**INDIANA
MICHIGAN
POWER**

Subject: Donald C. Cook Nuclear Plant Units 1 and 2
Docket Nos. 50-315 and 50-316
Remainder of Response to Request For Additional Information Regarding License
Amendment Request to Extend the Allowed Outage Times for Emergency Diesel
Generators, 69 kV Offsite Power Circuit, Component Cooling Water, and Essential
Service Water (TAC Nos. MC4525 and MC4526)

REMAINDER OF RESPONSE TO REQUEST FOR ADDITIONAL INFORMATION
REGARDING LICENSE AMENDMENT REQUEST TO
EXTEND ALLOWED OUTAGE TIMES

FIGURE
SUPPLEMENTAL DIESEL GENERATORS
ONE-LINE DIAGRAM

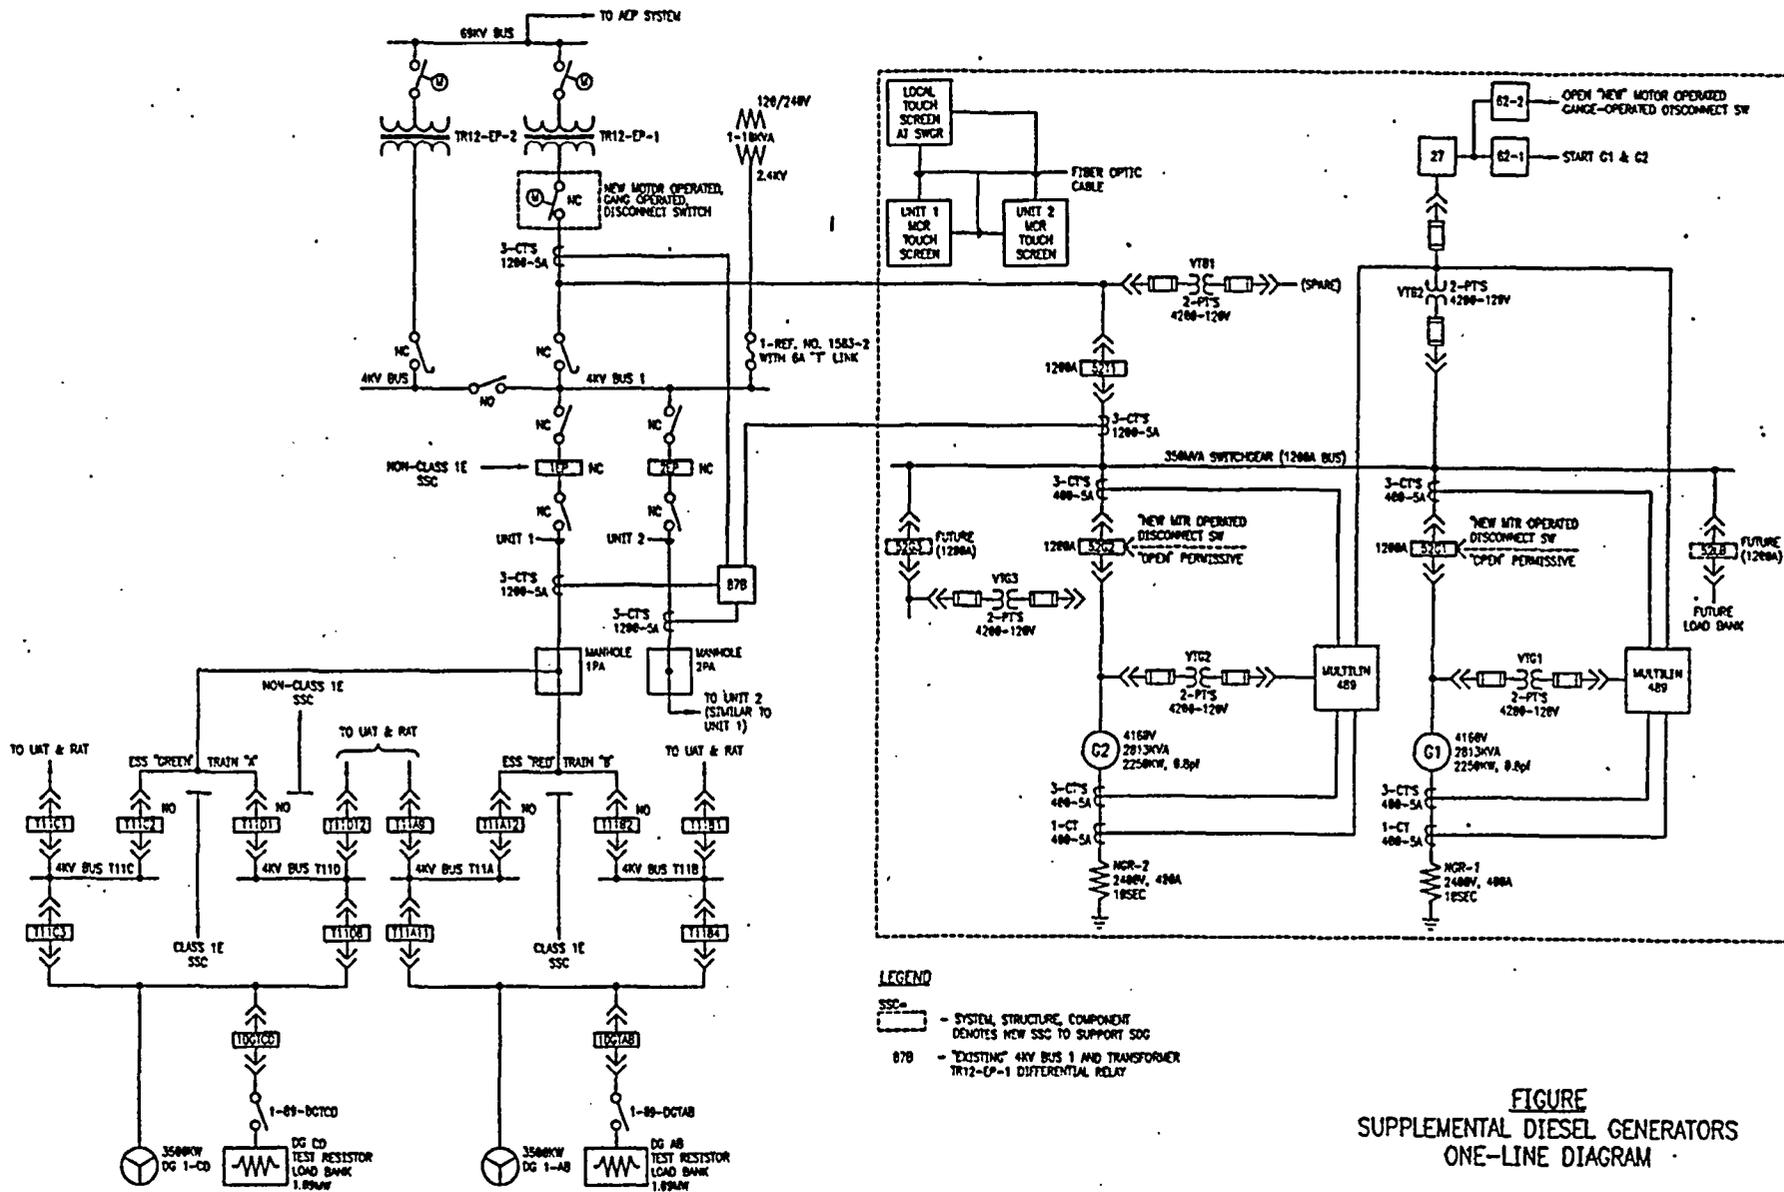
Section 4.1 of the submittal discusses the SDGs. Do the SDGs require any support systems (e.g., electric power, cooling water, heating, ventilation, and air conditioning, instrumentation and control) in order to start and run? What support (e.g., DC control power) is needed for the circuit breakers connecting the SDGs to buses T11A (T21A), T11B (T21B), T11C (T21C), and T11D (T21D)? How were these dependencies addressed in the model used to calculate the new base case and other plant configurations for the risk assessment? (RG 1.174, Section 2.2.2; RG 1.177 Section 2.3)

- The figure at the end of Enclosure 2 to the letter from J. N. Jensen, I&M, to NRC Document Control Desk, AEP:NRC:4811, dated September 21, 2004 (ML042780478), provided a oneline electrical diagram of the SDGs.

An updated figure is provided at the end of this attachment.

The updated design includes electrically-operated breakers (52G1 and 52G2, see the attached updated figure) on the discharge of each SDG, and an electrically-operated tie breaker (52T1, see the attached updated figure) between the SDG output breakers and the 4 kV Bus 1.

This description is revised to be as follows: Upon a sustained loss of power on 4 kV Bus 1, a new motor operated disconnect switch (within the dotted line on the updated figure) will automatically open to isolate the 69 kV system. When the motor operated disconnect switch is confirmed open, the two SDGs will automatically start. When the first SDG reaches rated speed and voltage, its output breaker will close. When the second SDG reaches rated speed and voltage, the two SDGs will synchronize and the second SDG output breaker will close. With both SDGs operating, the tiebreaker (52T1 on the updated figure) will close loading the SDGs onto 4 kV Bus 1.
